FINAL DRAINAGE PLAN

THE RIDGE AT LORSON RANCH

FILING NO. 1: SF 22-XX ← SF224

JANUARY, 2022

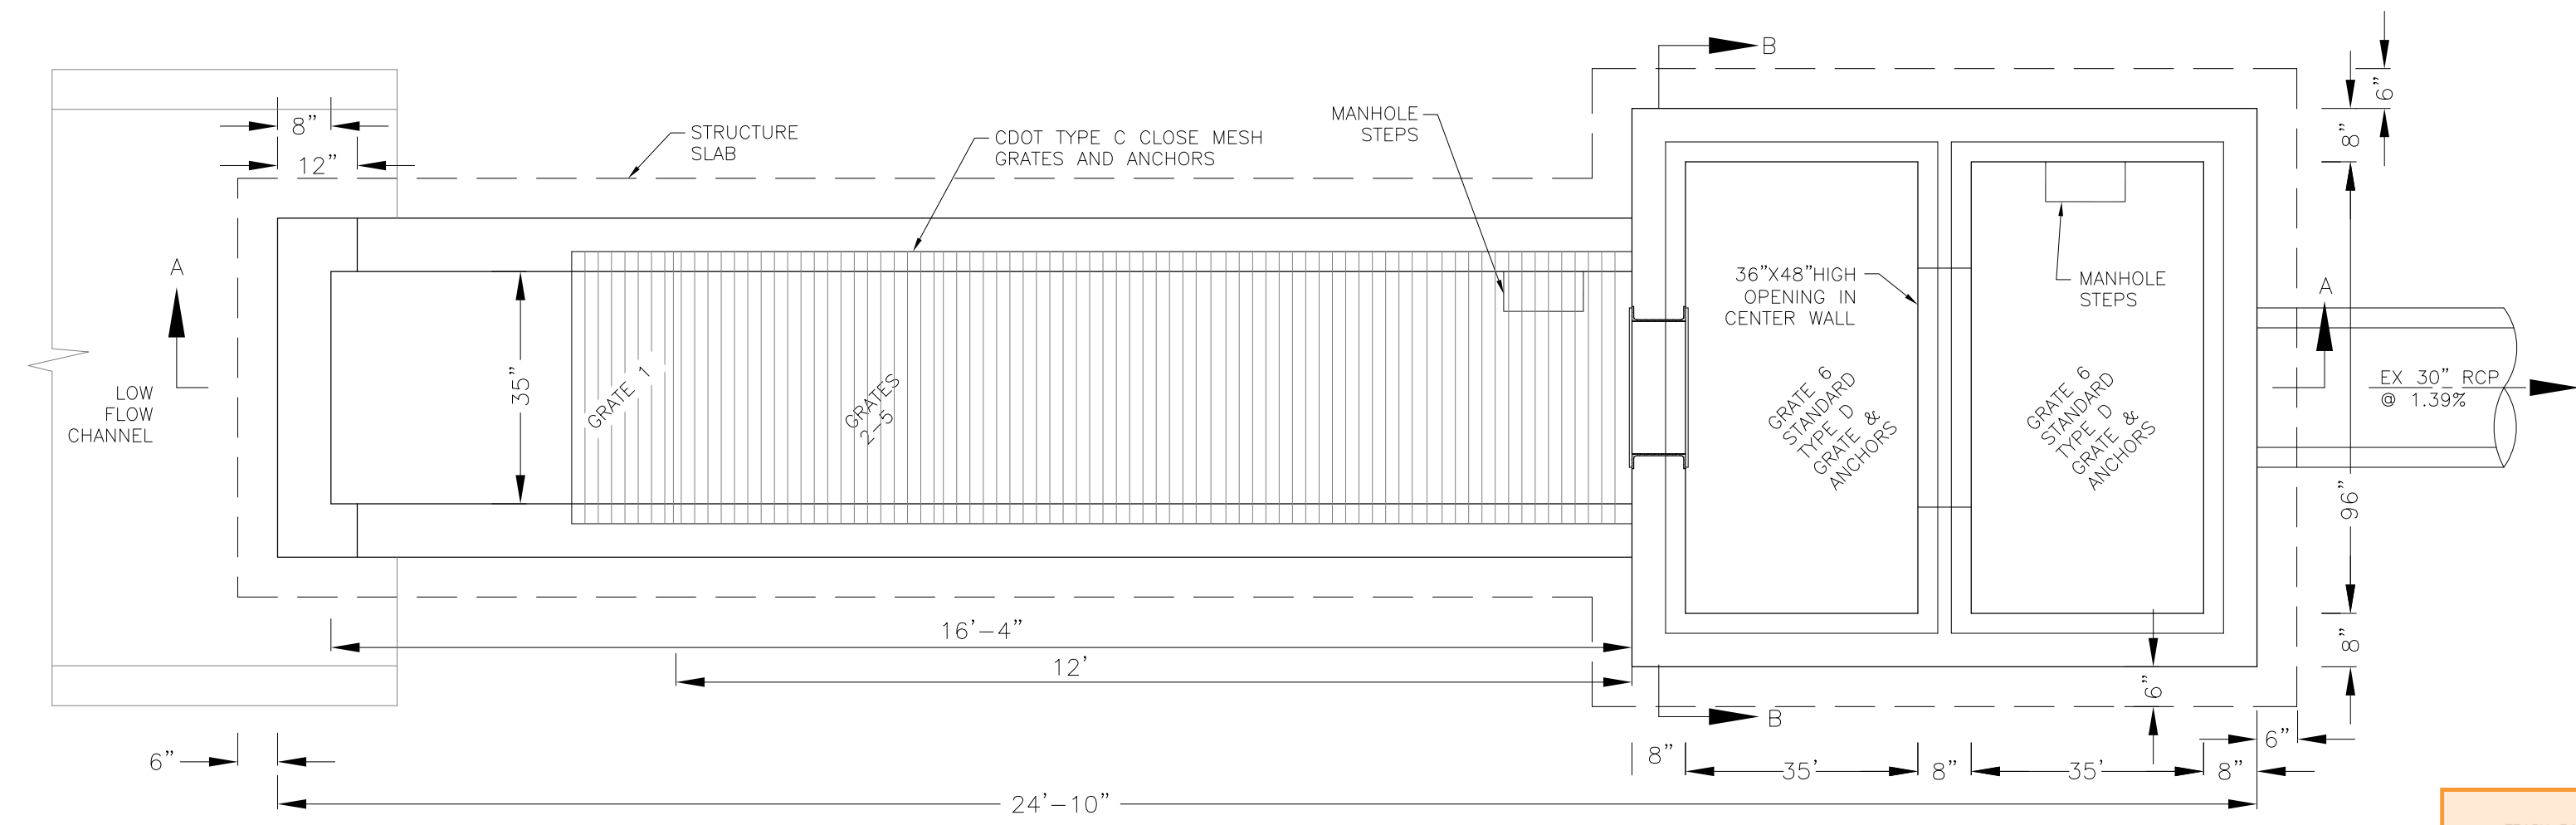
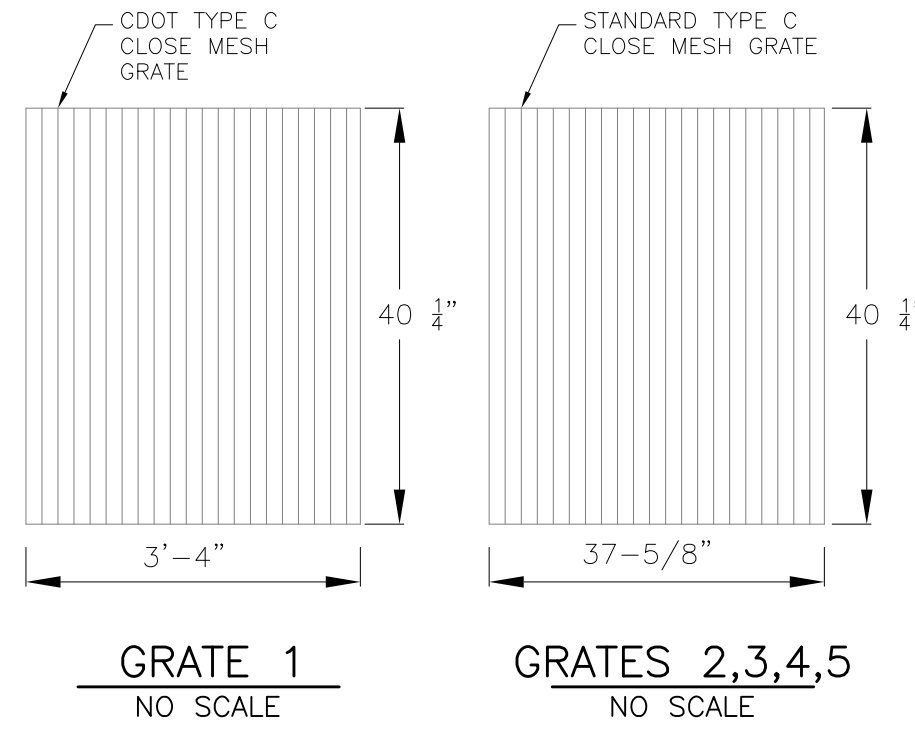
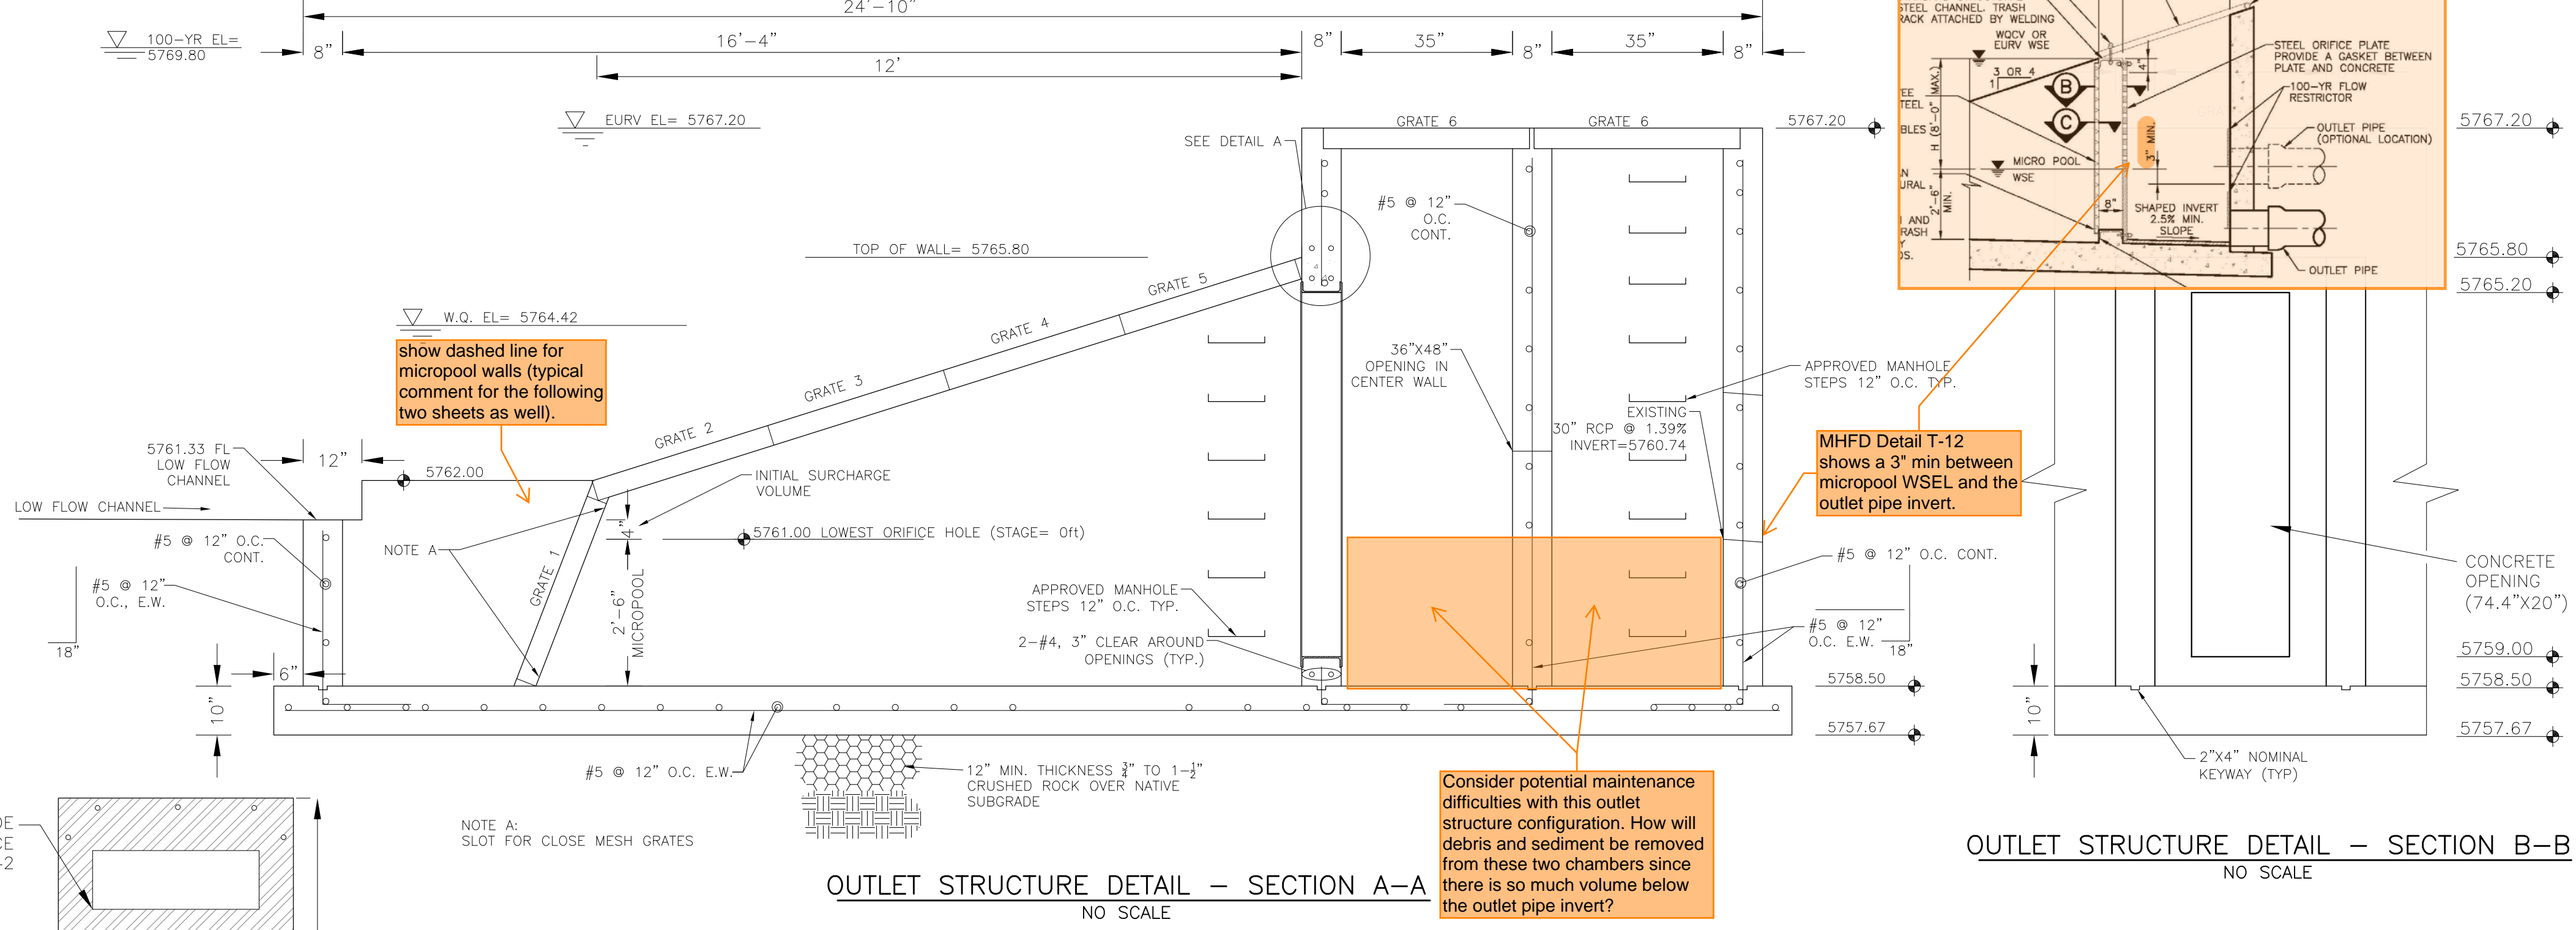
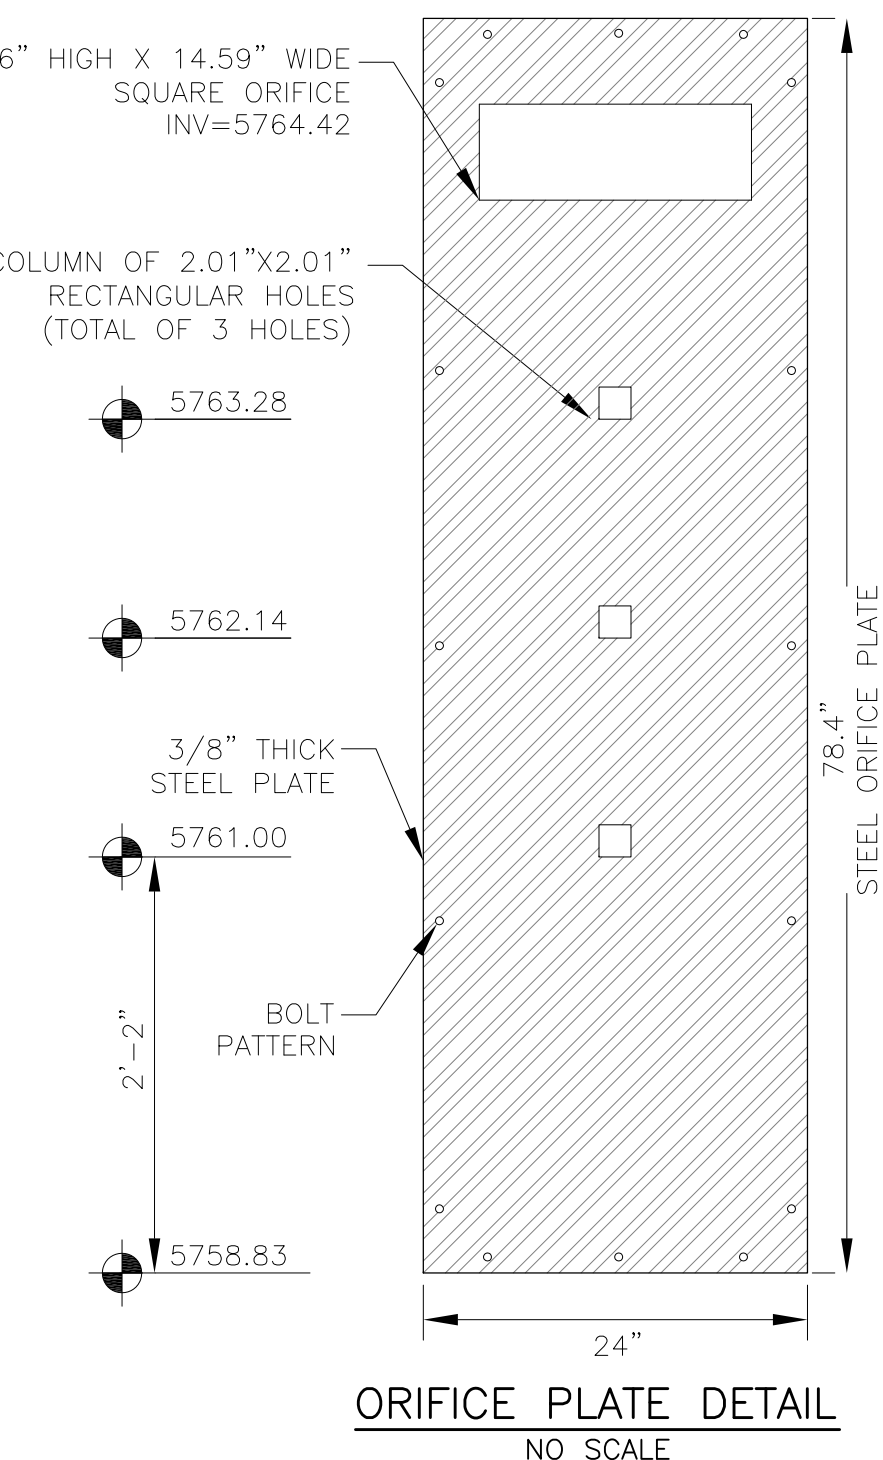
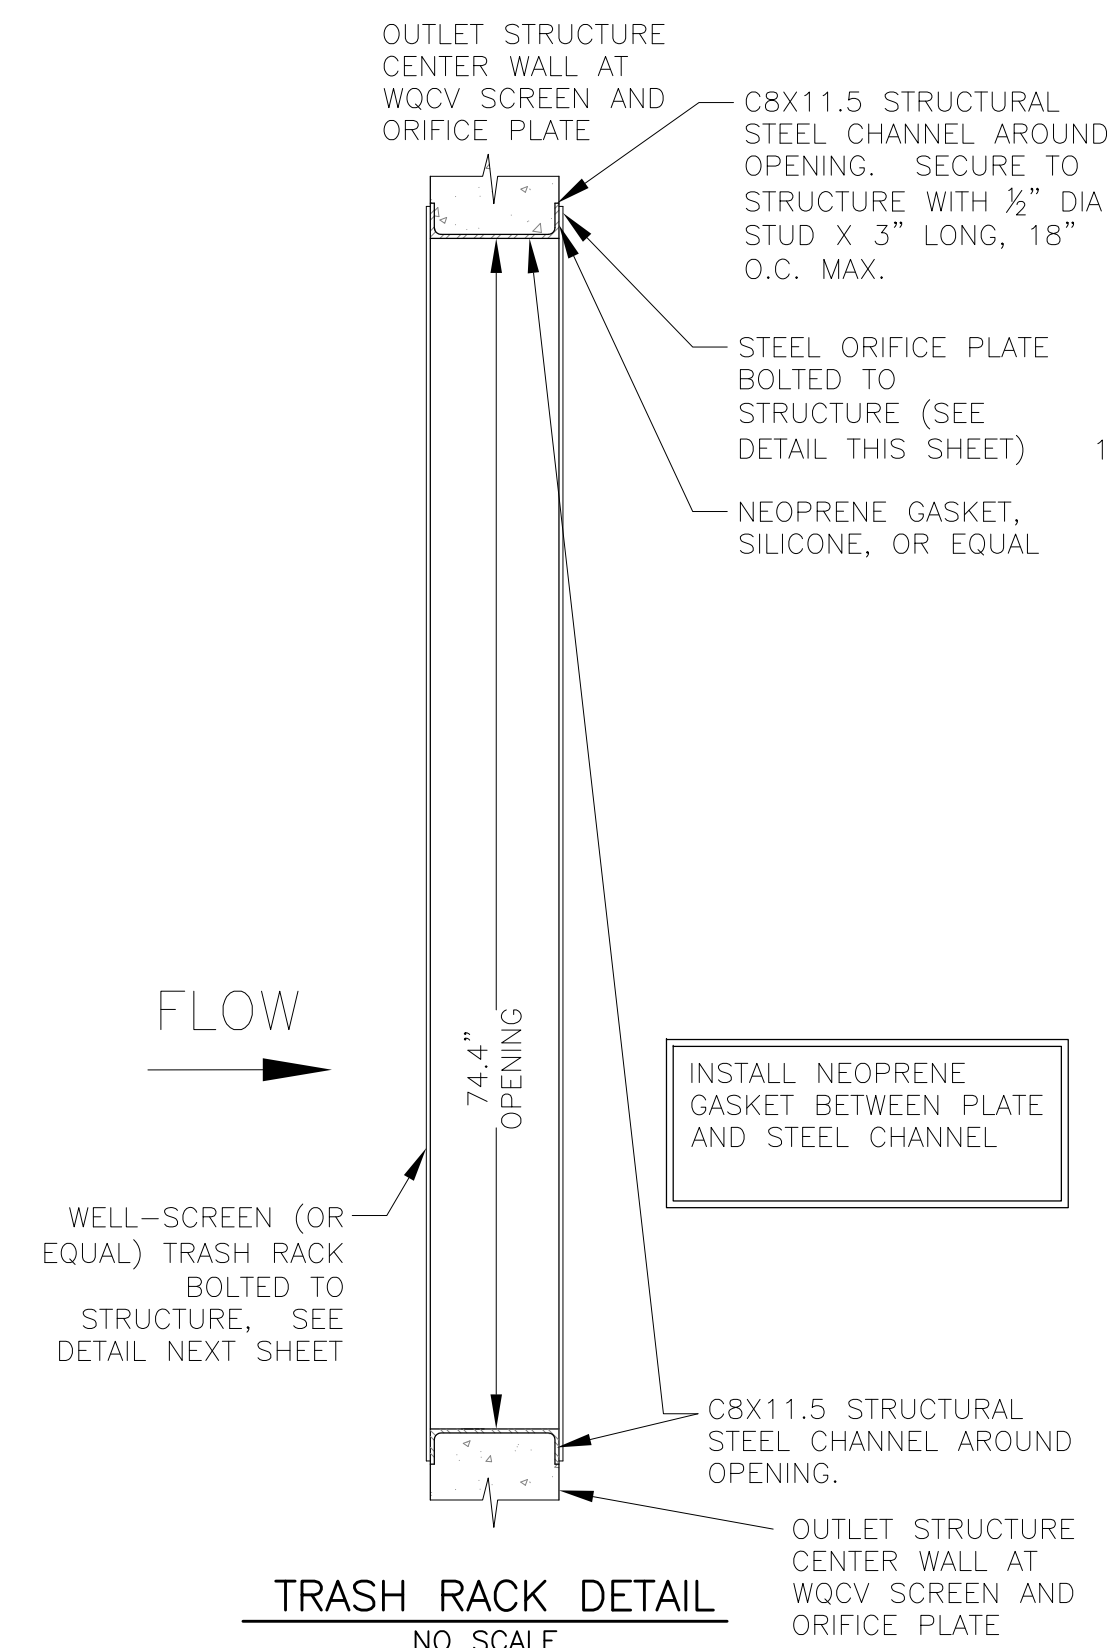
This sheet and the other two sheets below this one need to be included in the CD's.
